SERVICE INFORMATION

Throttle Advance Kit

Models affected: All HP 900SC Engines

KIT COMPONENTS

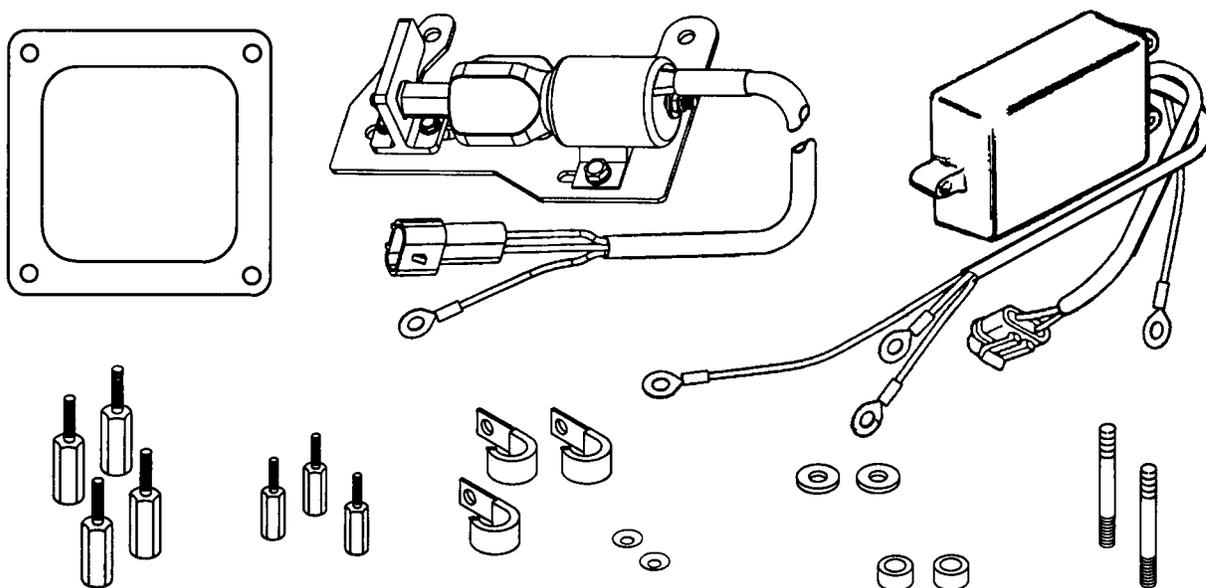
The 900 SC engine may stop running when put into gear if used with a large pitch propeller.

Mercury Racing has developed a throttle advance kit for the 900 SC that advances the throttles momentarily during shifting. If you have customers that require a kit for their engines, order P/N 845740A3. All engines currently being produced will have this kit installed at the factory.
